TECHNICAL SERVICE BULLETIN

20-2170

Water Leaking On Right Front Floor During Or After A/C Use - Built On 31-Aug-2018 And Through 02-Feb-2020

14 May 2020

Figure 2

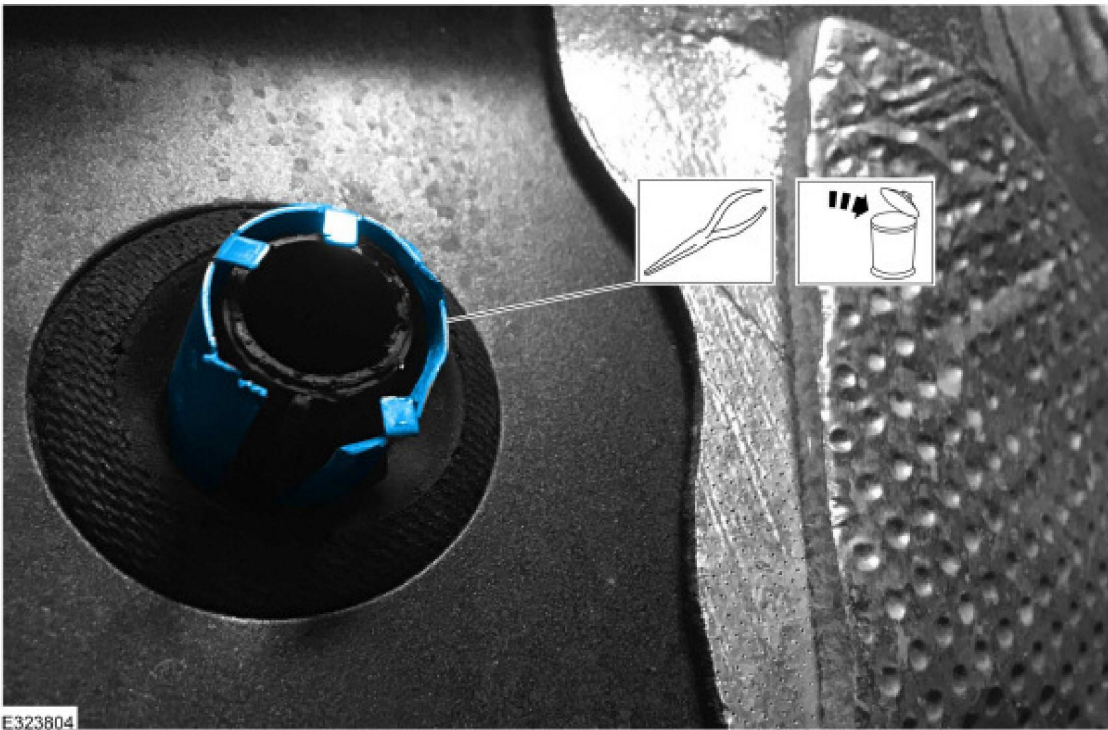
1. Raise the vehicle and remove the right front tire.
2. Remove the right front fender splash shield. Refer to the Workshop Manual (WSM), Section 501-02.
3. Using needle nose pliers or equivalent, remove and discard the metal shield from the evaporator drain tube by bending the tabs away from the tube. (Figures 1-3)

Figure 4

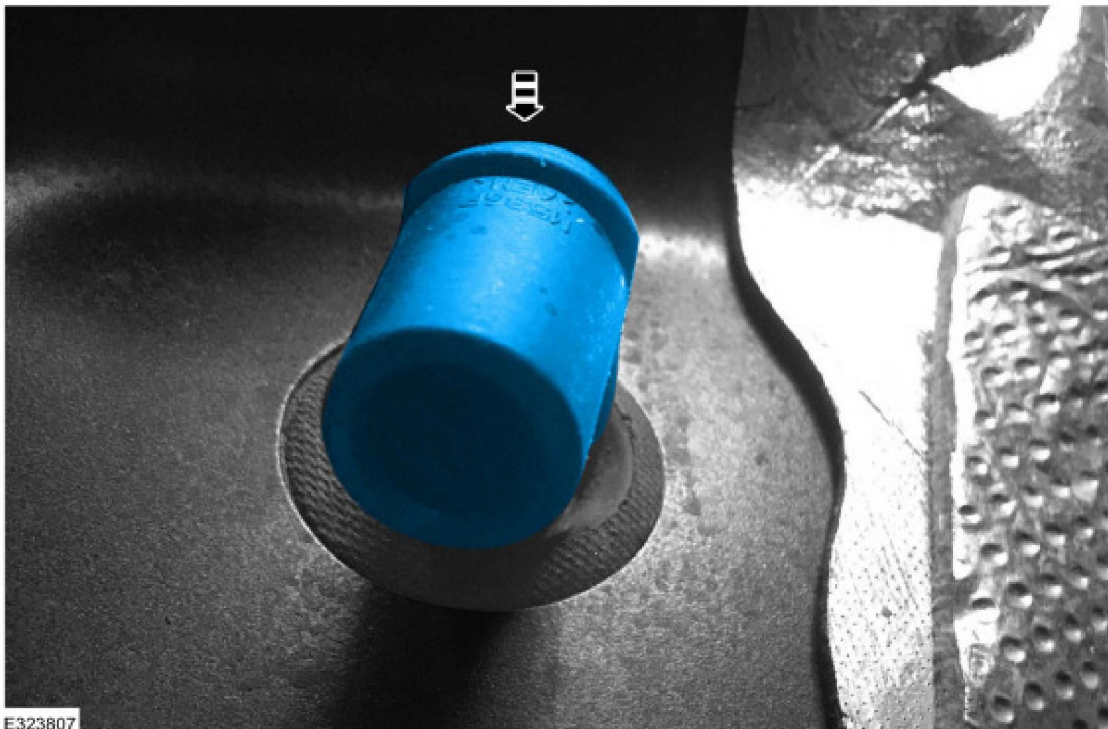
4. Lubricate the inside of the elbow with water. Install the short end of the elbow onto the drain tube. (Figures 4-5)
